Access Compliance Report

Public Rights-of-Way

(Curb Ramps)

Intersection ID: 10036505	Main Street: ROZZELLES_FERRY_RD	Cross Street: N/A	Location: W
ADA ID: AA1BFBC9CC67	Ramp Type: Perp	Initial Pass/Fail: Fail	Overall Compliance: No
			Severity Score: 25

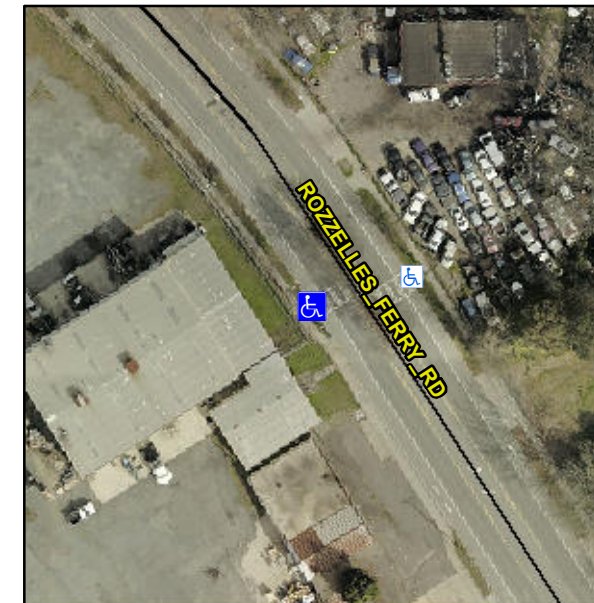
Not Found, R304.2.2

Compliance	Description	Data	Compliance	Description	Data
N/A	Ramp Length (in)	49.5	No	Ramp Slope (%)	15.1
Yes	Ramp Width (in)	52.0	Yes	Ramp XSlope (%)	2.0
N/A	Flare Type LT	N/A	N/A	Flare Type RT	N/A
N/A	Flare Slope LT (%)	N/A	N/A	Flare Slope RT (%)	N/A
N/A	Flare Traversable LT?	N/A	N/A	Flare Traversable RT?	N/A
N/A	Landing Length (in)	N/A	N/A	DWS Provided?	N/A
N/A	Landing Width (in)	N/A	N/A	DWS Contrast?	N/A
N/A	Landing Slope (%)	N/A	N/A	DWS Length (in)	N/A
N/A	Landing X Slope (%)	N/A	N/A	DWS Full Width?	N/A
N/A	Landing Curb? (Y/N)	N/A	N/A	DWS Offset (in)	N/A
N/A	Shared Landing?	N/A			
N/A	Gutter Ponding?	N/A	N/A	Gutter Slope (%)	N/A
N/A	Gutter Lip Ht (in)	N/A	N/A	Gutter X Slope (%)	N/A
N/A	Painted X Walk1?	Yes	N/A	Painted X Walk2?	N/A
	X Walk 1 Direction	To E		X Walk 2 Direction	N/A
N/A	X Walk 1 Width (in)	111.0	N/A	X Walk 2 Width (in)	N/A
	X Walk 1 Slope (%)	5.4		X Walk 2 Slope (%)	N/A
	X Walk 1 X Slope (%)	2.9		X Walk 2 X Slope (%)	N/A

Remove & Replace Entire Ramp.
